FSD Circular Letter No. 3/2006
Specification for Automatic Sprinkler Installations

This Circular Letter announces the adoption, with local modifications, of LPC Rules for Automatic Sprinkler Installations incorporating BS EN12845.

Recommendation of Fire Safety Standard Advisory Group

Figure TB209.F5 Two suction pump connections to two half capacity tanks

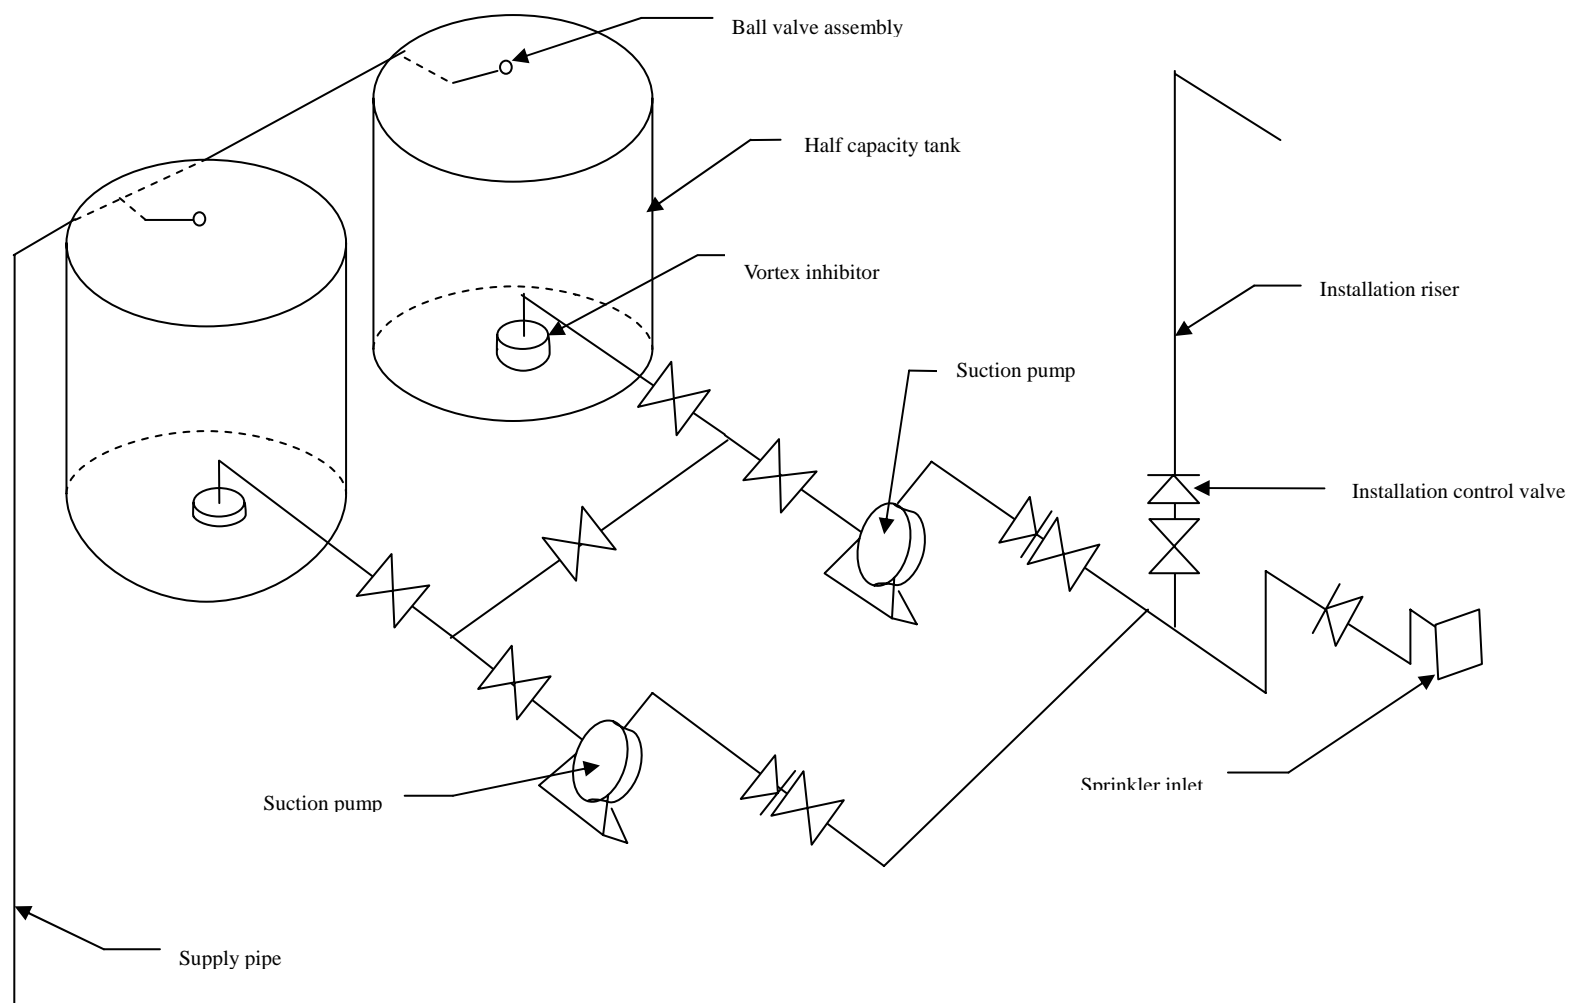
2.105	Figure TB209.F5 (TB209, Page 15)	Some wordings inside the figure shall be amended.	<p>(a) “Diesel pump” as “Suction pump”, and</p> <p>(b) “Electric pump” as “Suction pump”</p> <p>(amended Figure TB209.F5 at Annex I refers)</p>	To suit local requirements.

-	<p>Add the following pipeline with valves :</p> <p>(a) pipeline with check valve and sprinkler inlet between the existing pump discharge valve and installation control valve, and</p> <p>(b) supply pipe with ball valve assembly</p> <p>amended Figure TB209.F5 at Annex I refers)</p>	To suit local requirements.

Figure TB 210.F1 Typical jockey pump arrangement

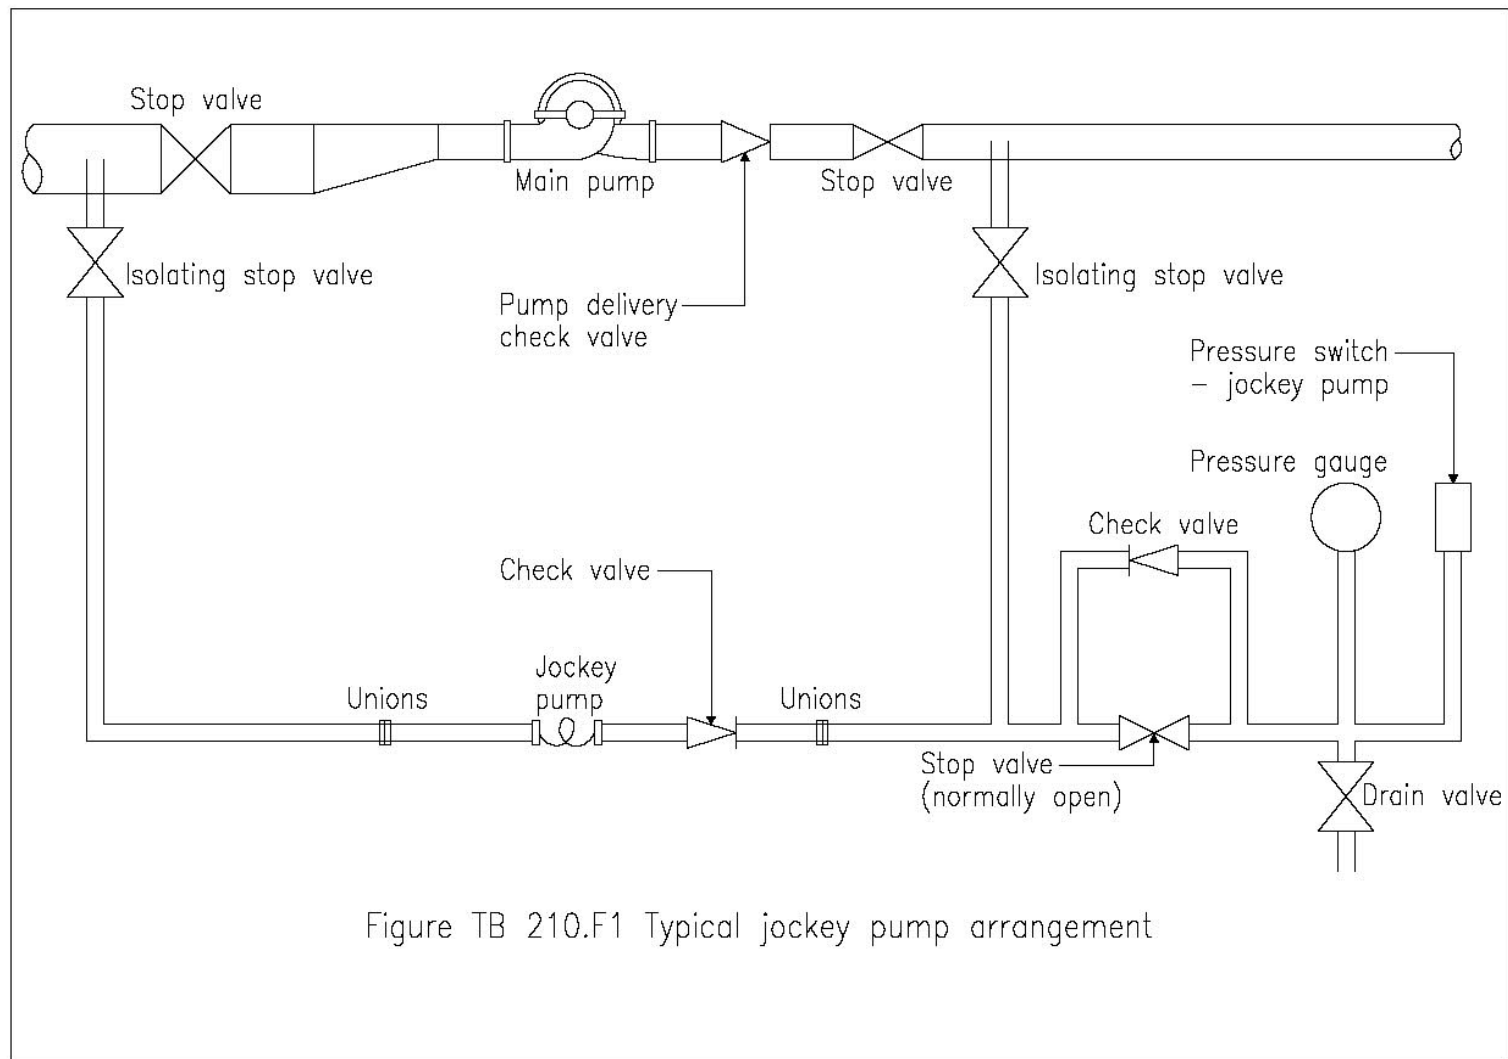
2.108	Figure TB210.F1 (Page 3 of 6)	Typical jockey pump arrangement	The jockey pump suction pipe should be connected to the upstream side of the sprinkler pump suction stop valve as indicated in Annex II.	To obviate interruption to the jockey pump operation when the sprinkler pump is isolated for whatever reason.

Figure TB 218.F2 Superior supply using suction pumps

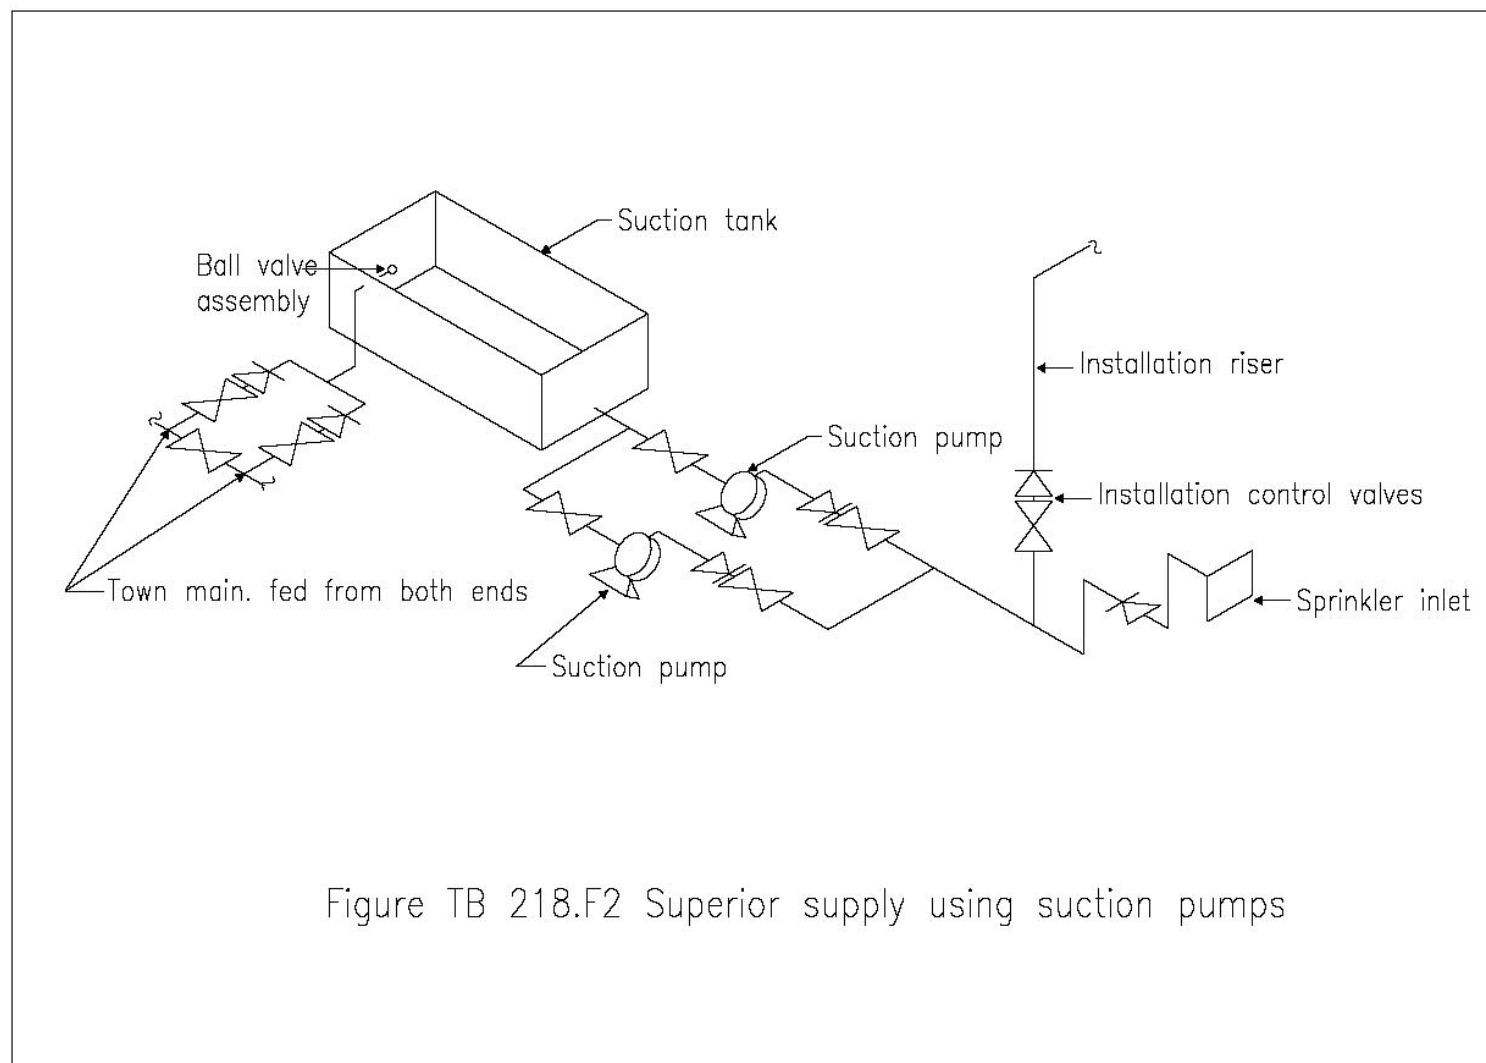
2.114	TB218:2004 (Page 2 of 6) TB218:2004 (Page 6 of 6)	Figure TB218.F2 Superior supply using suction pump Figure TB218.F6 Duplicate supplies using two suction pumps from a limited capacity tank and full capacity tank	Delete the connection for non-sprinkler installation and add Fire Service inlet connection before the installation control valve. Change description for diesel and electric pump as suction pump. Refer to Annex III for detail. Delete the connection for non-sprinkler installation and add Fire Service inlet connection before the installation control valve. Change description for diesel and electric pump as suction pump. Refer to Annex IV for detail.	To suit local practice.
